# PRODUCT CHANGE NOTIFICATION

## Bourns® Model SRN5020TA, SRN5040TA and SRN6045TA Series Semi-shielded Power Inductors

### Carrier Tape Design Change

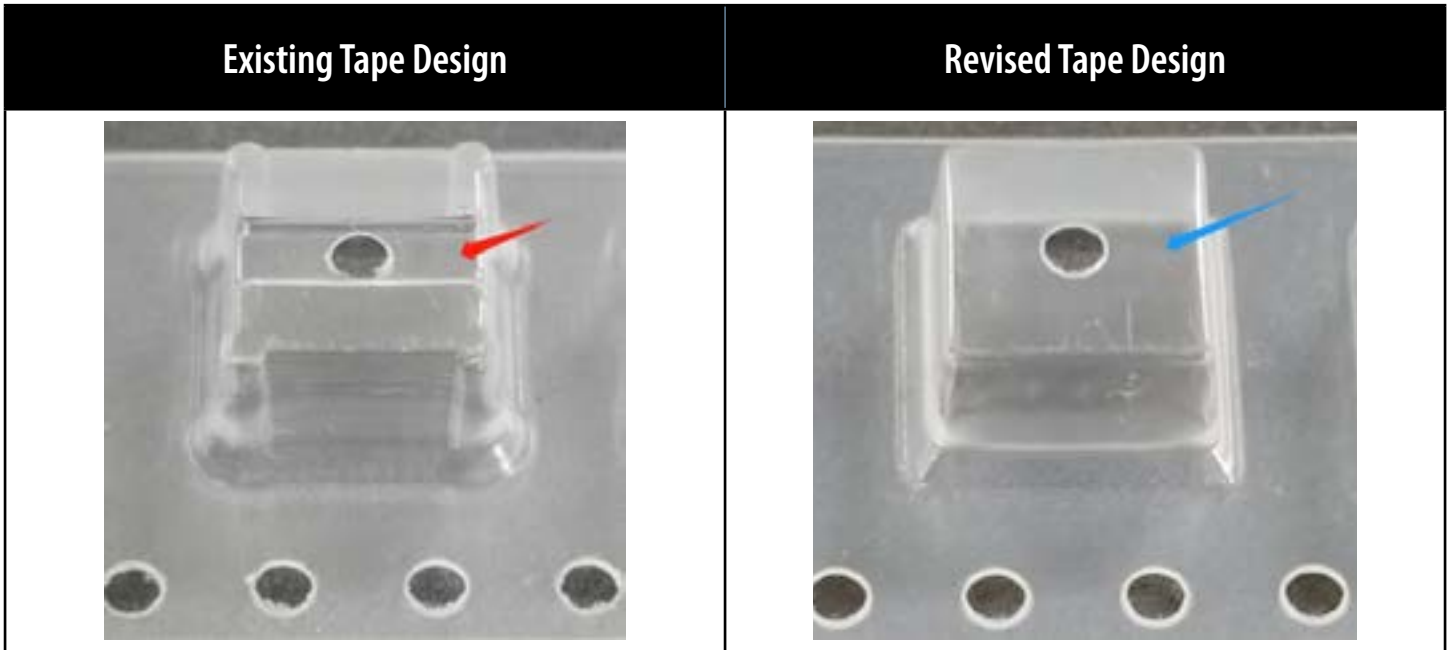
Riverside, California - February 6, 2024 – As part of our continuous improvement efforts, effective May 15, 2024, Bourns will change the design of the carrier tape for the Model [SRN5020TA](#), [SRN5040TA](#), and [SRN6045TA](#) Series Semi-shielded Power Inductors. As shown in the figure on page 2, the modified carrier tape now has a flat bottom design. A list of affected part numbers is included below.

The form, fit and function of the inductors will not change as a result of this change to the carrier tape. The quality and reliability of the inductors should be improved with the change to the carrier tape. Traceability will be maintained through lot code and date code.
